Re: Lahontan Regional Water Quality Control Board Request for Public Comments on the Modification of Whole House Replacement Cleanup and Abatement Order (R6V-2011-0005A1 & R6V-2011-0005A2) dated February 20, 2013

Key Words: PG&E's Five (5) Requests Pertaining to Amending Ordered Work Under the Whole House Replacement Water Program (January 10th and February 7th, 2013); Water Board's Request for Public Comments (February 20th, 2013); CAC and IRP Manager's Opinions and Comments.

FIGURE 1: Path Forward for the Modifications to the Whole House Replacement Water (WHRW) Program.

Table 1: Summary of IRP Manager's Comments Regarding PG&E's Requested Modifications to the Company's Whole House Replacement Water (WHRW) Program¹

TABLE 1, FIGURE 3A

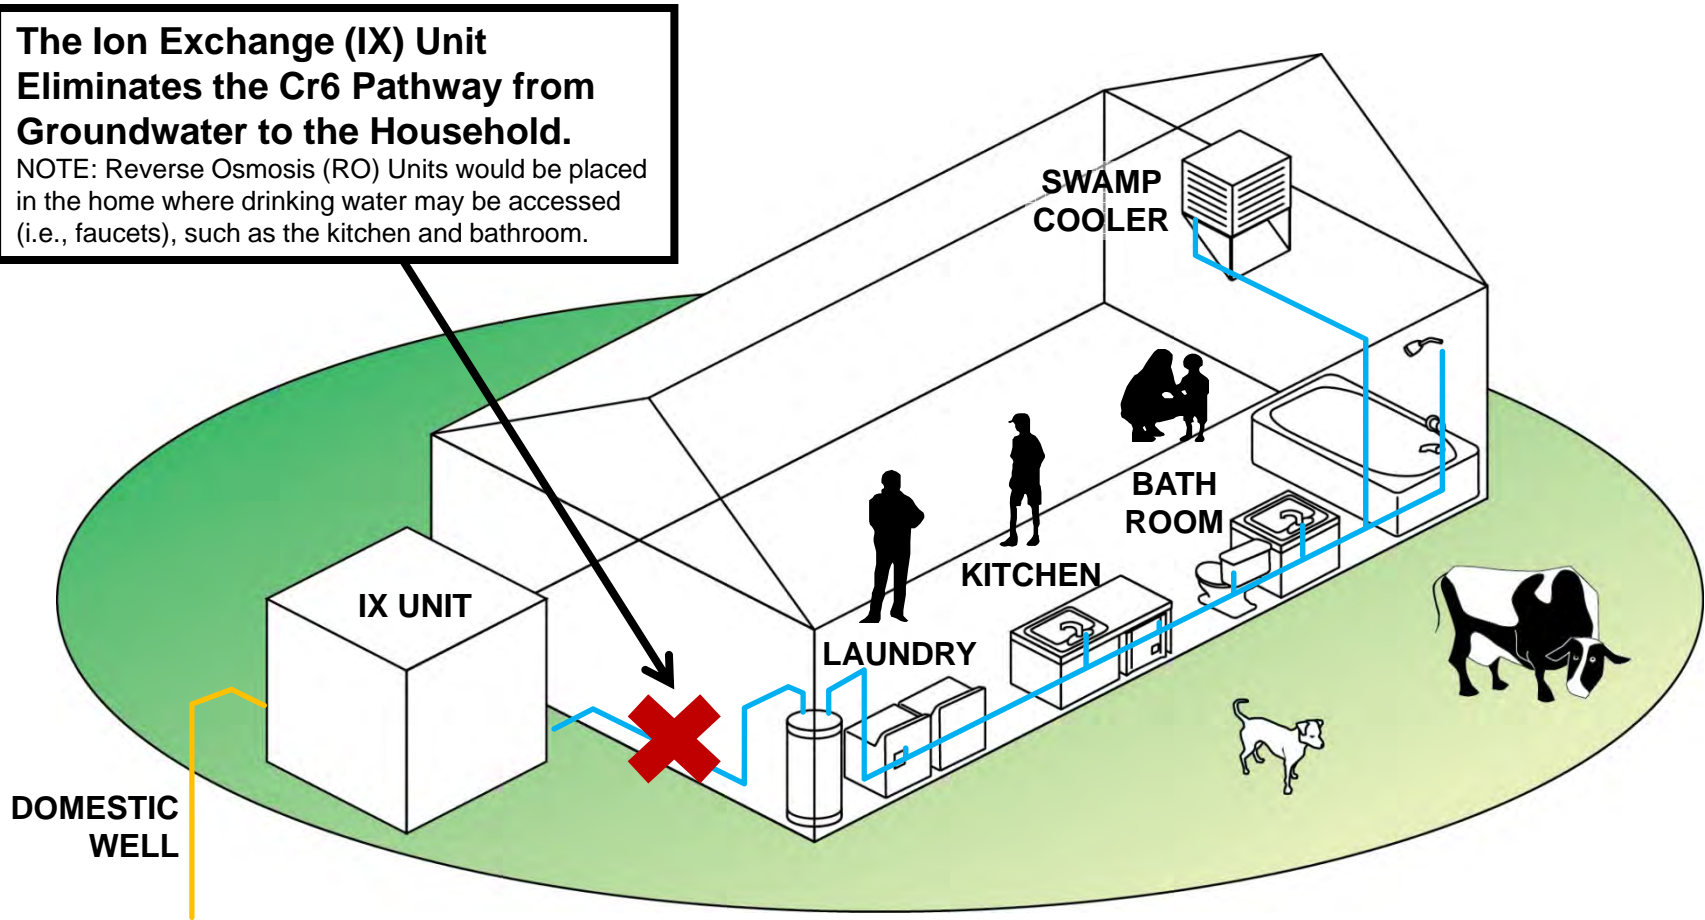
Under-sink RO Monitoring Modifications:

The CAC believes¹⁰ that “PG&E is having an issue with the RO units, not because a resident has a problem with the functionality of the RO units. The concerns stem from the intrusiveness of PG&E coming into our homes much more than originally stated by both their experts and PG&E. If the RO unit can be placed under the sink and only needs annual or semi annual checks to replace filters it is acceptable. Otherwise the CAC and Water Board can only come to the one conclusion that the RO unit does not work properly. In which case PG&E, who researched and chose the system, and had the appropriate time to test it's efficiency is in violation of the revised Order and original Order should be reapplied.”

Many Community members have expressed concerns about the length of time and intrusiveness of RO unit monitoring¹¹. The CAC does understand that the degree of monitoring and servicing of the RO units becomes a balancing act for PG&E: i.e. enough monitoring to insure operational performance, but at a low enough frequency, to maintain a cordial working relationship with the homeowner. We are also basing our opinion on the fact that each RO unit will operate with the State-required automatic shutdown feature referred to in Footnote 7. However, we are

recommending that ***all under-sink RO units*** are tested every six months, and not just the unit located in the kitchen.

TABLE 1, FIGURE 5C

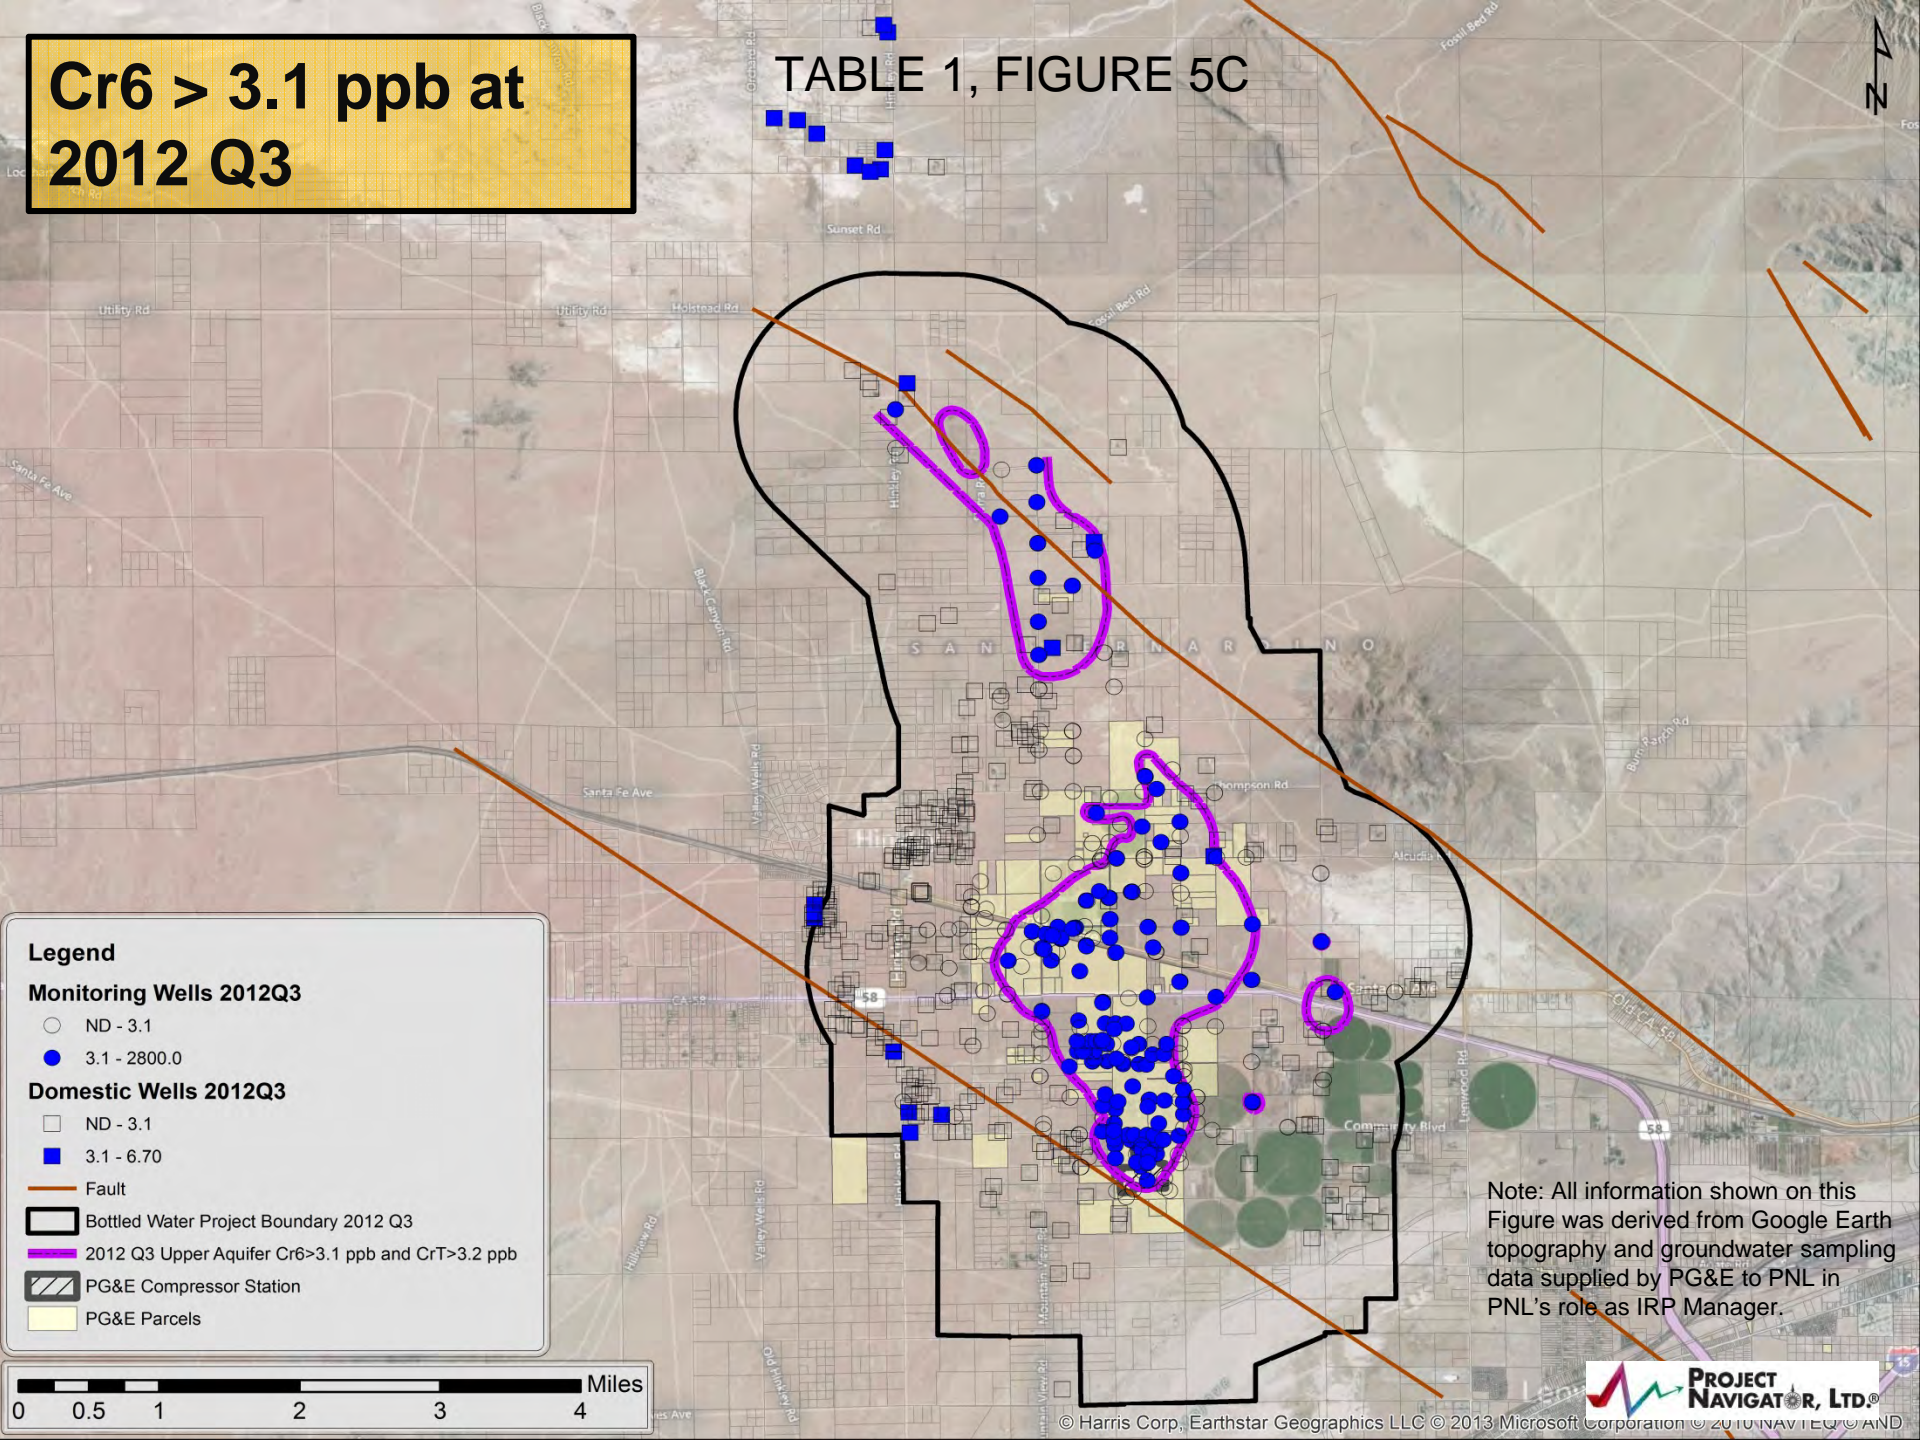
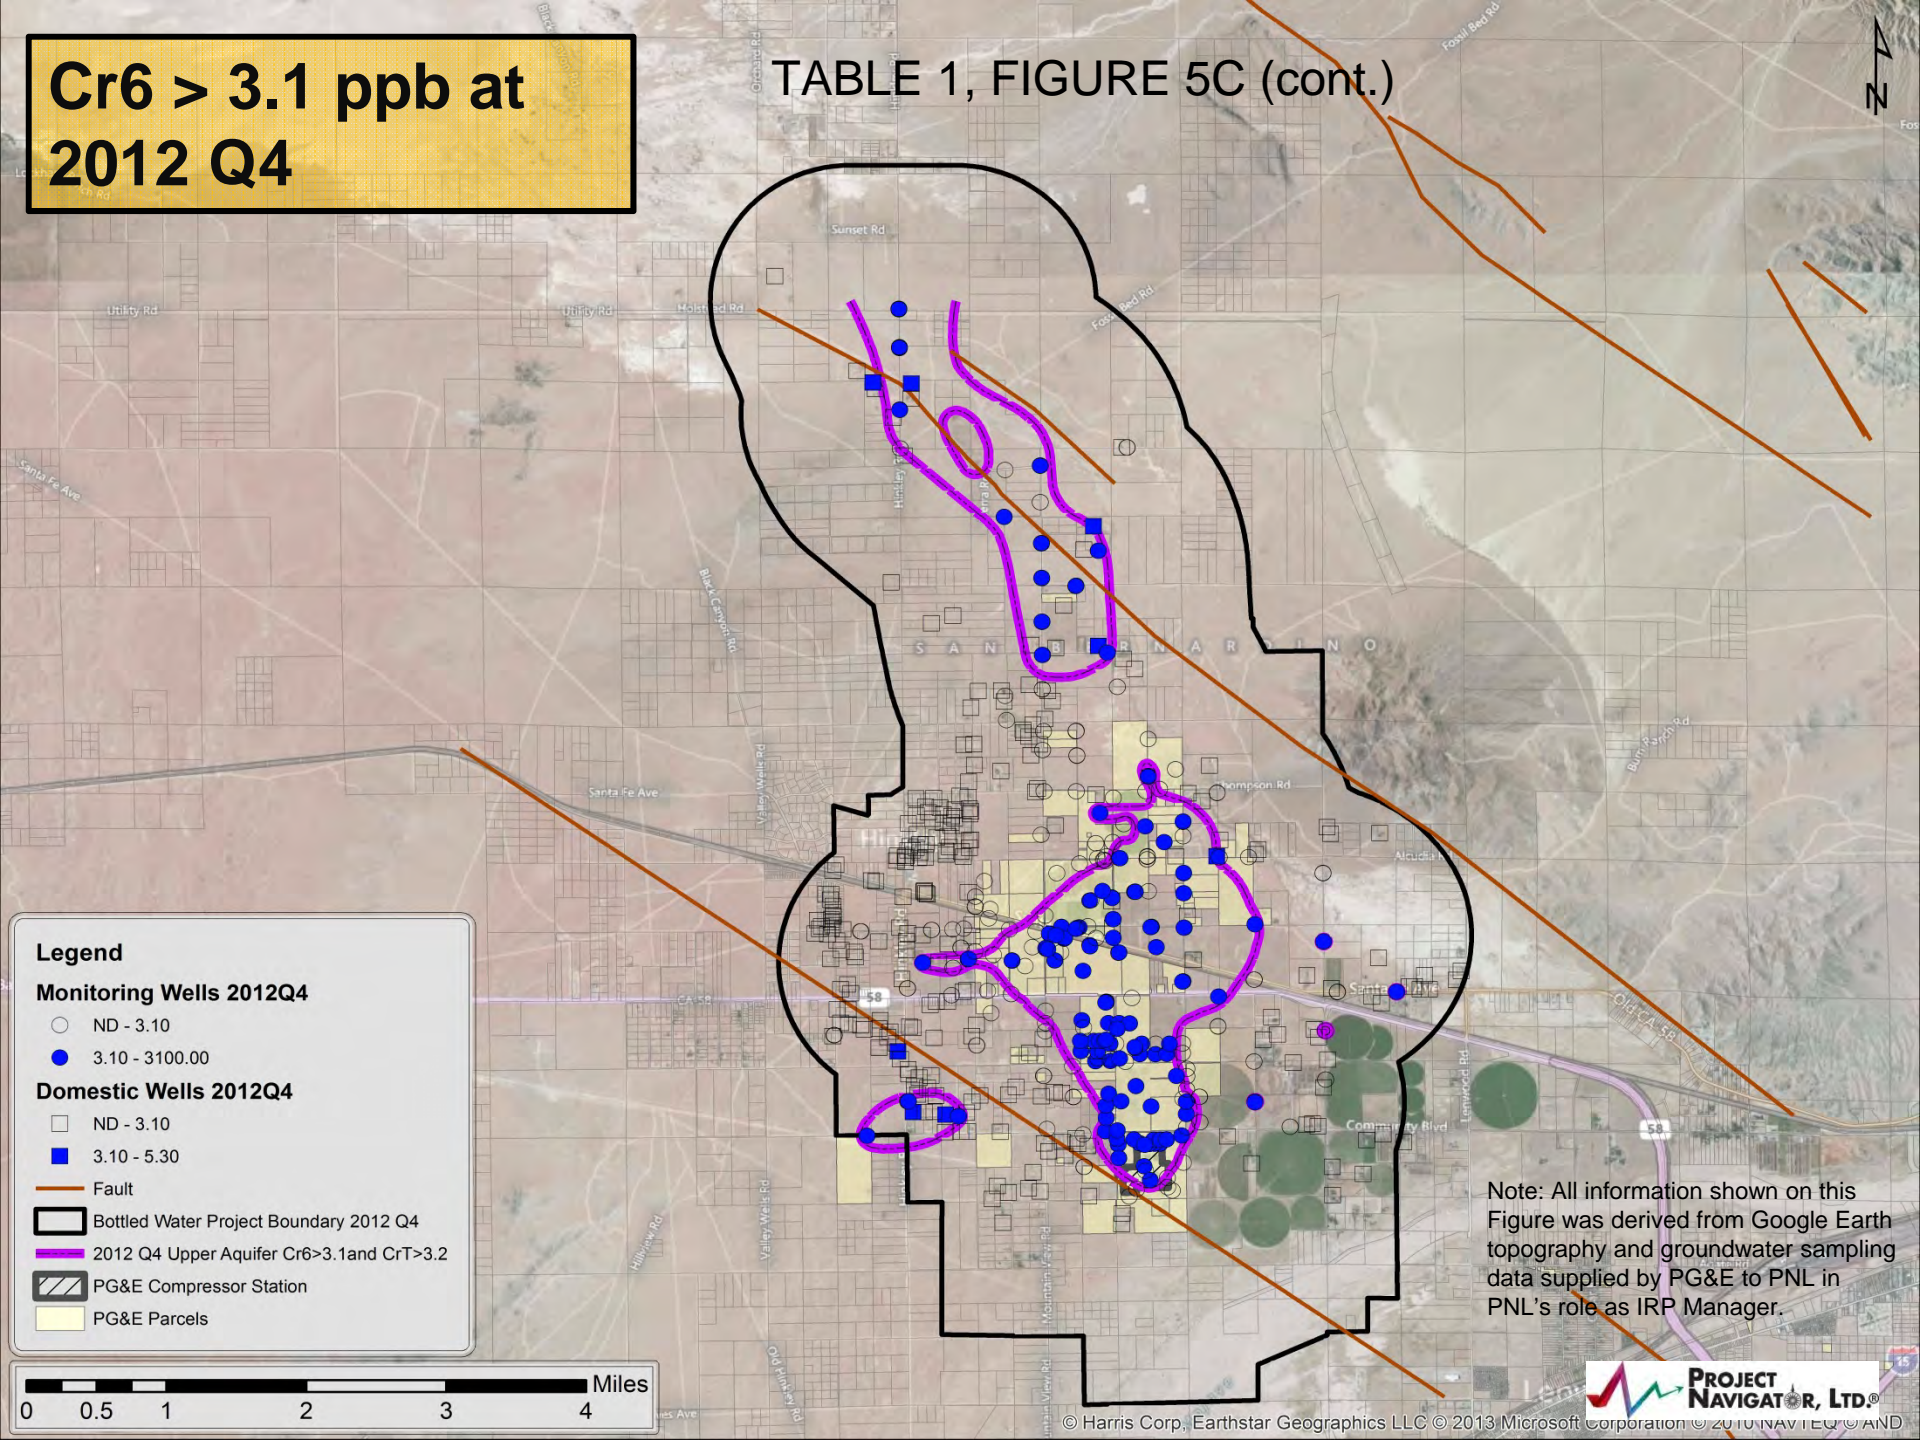
The CAC believes¹⁷ that "the one mile buffer needs to also be expanded if any measurable amounts of chromium 6 are determined to be due to PG&E's discharge whether the measurable number is below or above (the current, upper background of) 3.1 ppb Cr6. The buffer zone also needs to also include any measurable amounts of bi-products or any contamination due to PG&E's discharge or remediation. Basically the Plume is still not defined."

The CAC and the IRP Manager agree that the generation of the 1-mile buffer zone and contouring of the greater than 3.1 µg/L Cr6 plume should *not only* be based on Chromium data¹⁸ but also should consider new key variables¹⁹, such as:

- Historical and current groundwater level, pumping and groundwater flow direction data
- Effects of local faulting
- Geochemical data
- Isotopic data

The CAC and the IRP Manager recommend that a Technical Exchange Meeting (TEM)²⁰ process, involving key stakeholders (PG&E, Water Board and USGS),

should be initiated to determine how to proceed with re-evaluating the 1-mile buffer zone.
